State of Vermont Department of Health

Radioactive Materials Program

Procedure 2.5, Revision 0

Enforcement, Escalated Enforcement, and Administrative Actions

Enforcement Process

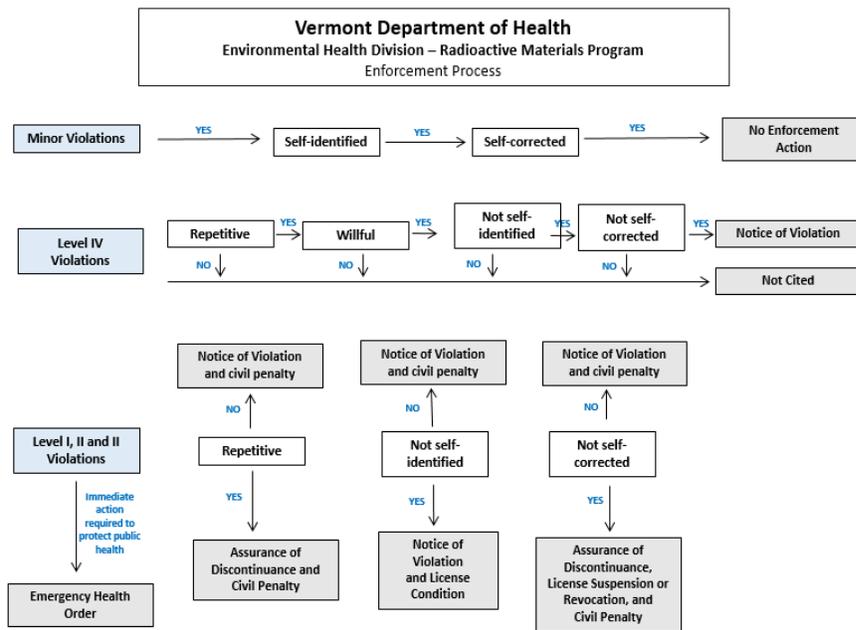
Commented [SJ40]: This chart should be revised as follows:

- The “not self-identified” boxes are confusing because of the double negative. Suggest that VT make all those boxes “self-identified” like the minor violations flow chart path.
- Suggest revising the “not self-corrected” boxes to “self-corrected” for the same reasons—i.e., the double negative is confusing.
- There is a typo in the “Level, I, II, and III Violations” box—II is listed twice.
- To model the NRC’s enforcement program, willfulness (i.e., careless disregard OR deliberateness) should play a role in the SL I-III violations. The NRC may escalate if willfulness is involved – e.g., a willful SL IV can become an SL III.
